**BEFORE
THE OHIO POWER SITING BOARD**

In the Matter of the Application of Juliet)
Energy Project, LLC for a Certificate of)
Environmental Compatibility and Public) Case No. 20-1760-EL-BGN
Need for a Solar Facility Located in Wood)
County, Ohio.)

**JULIET ENERGY PROJECT, LLC'S
RESPONSE TO OPSB STAFF'S SECOND DATA REQUEST**

Juliet Solar Project - Landscape Mitigation and Adjacent Residences with a Direct, Unobstructed Line of Sight

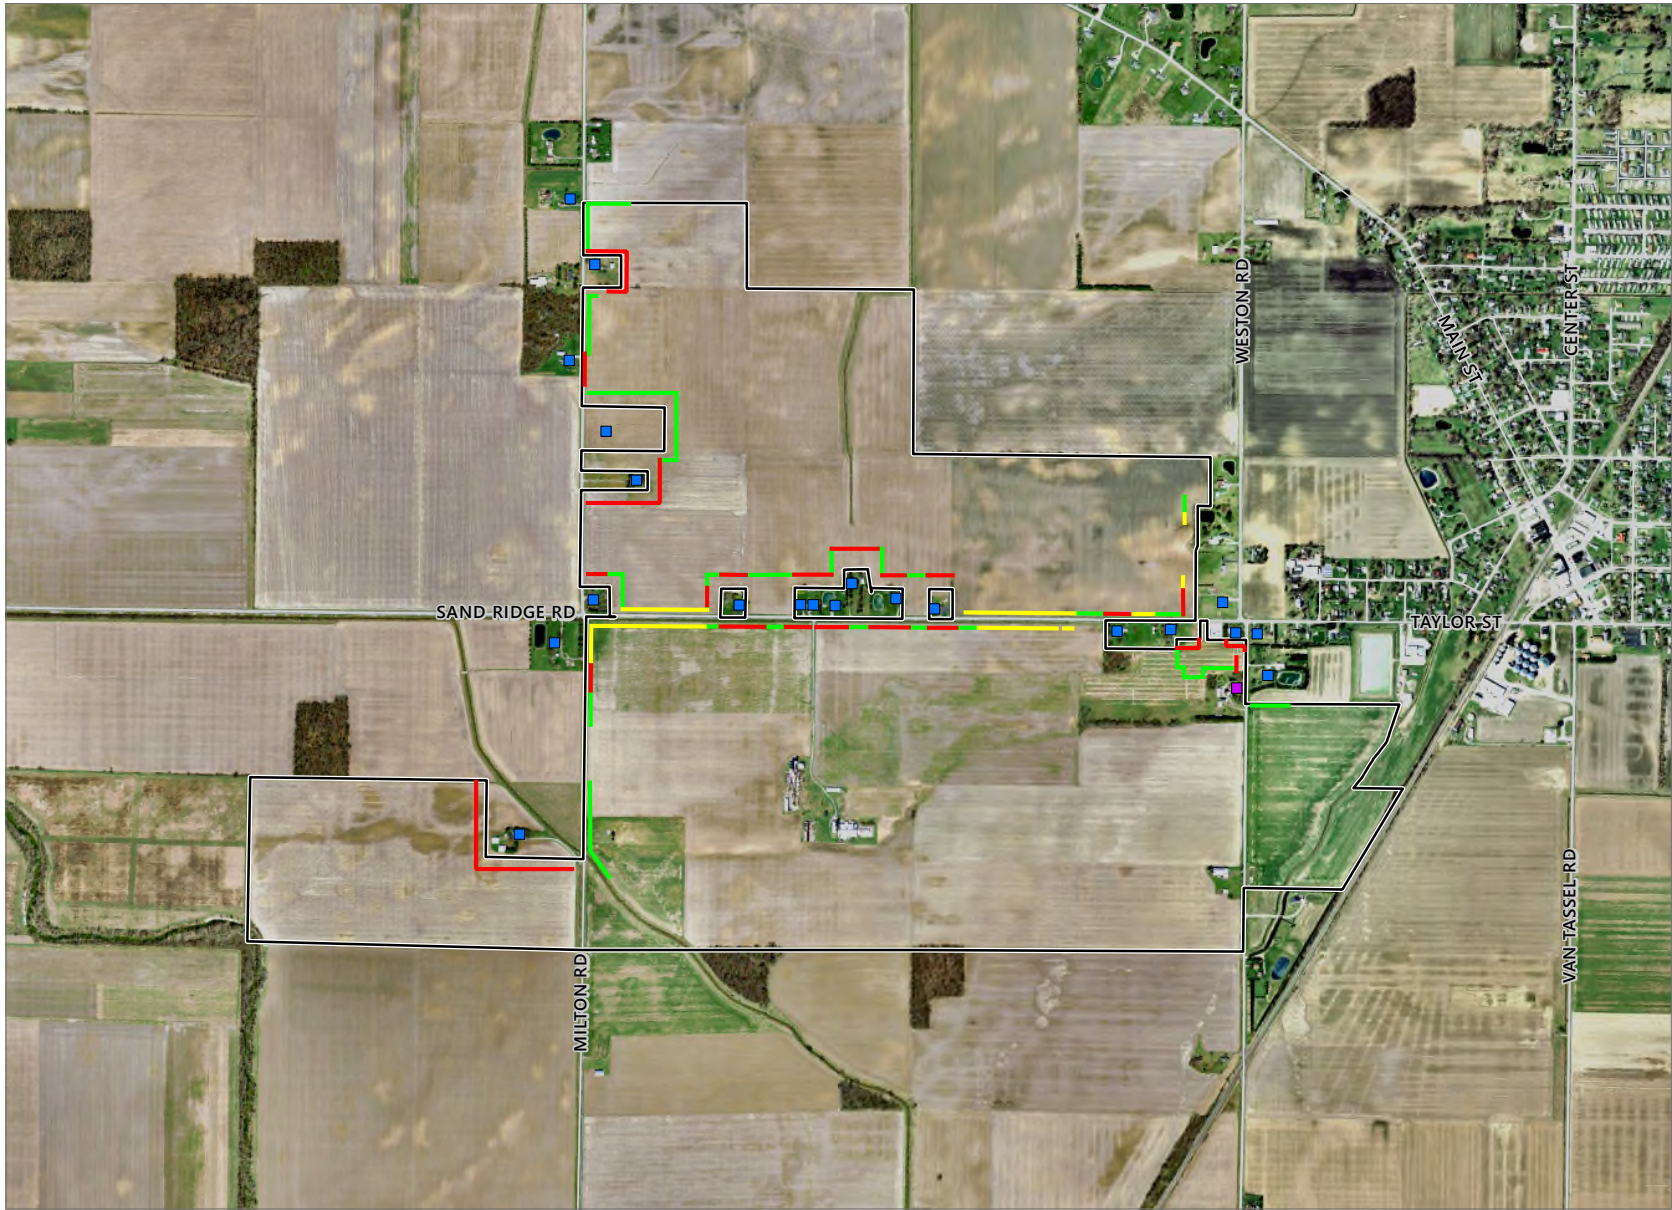
2. In addition to the visual planting modules map included in the application, provide a large-scale aerial map that depicts all inhabited residential dwellings adjacent to the project area that have a direct, unobstructed line-of-sight view to the project boundaries. Identify on the map which receptors are participating and non-participating, as well as any nearby roads and highways.

ANSWER: See attached map. Direct, unobstructed line-of-sight views were determined through a combination of viewshed analysis, review of updated aerial imagery, and site visits.
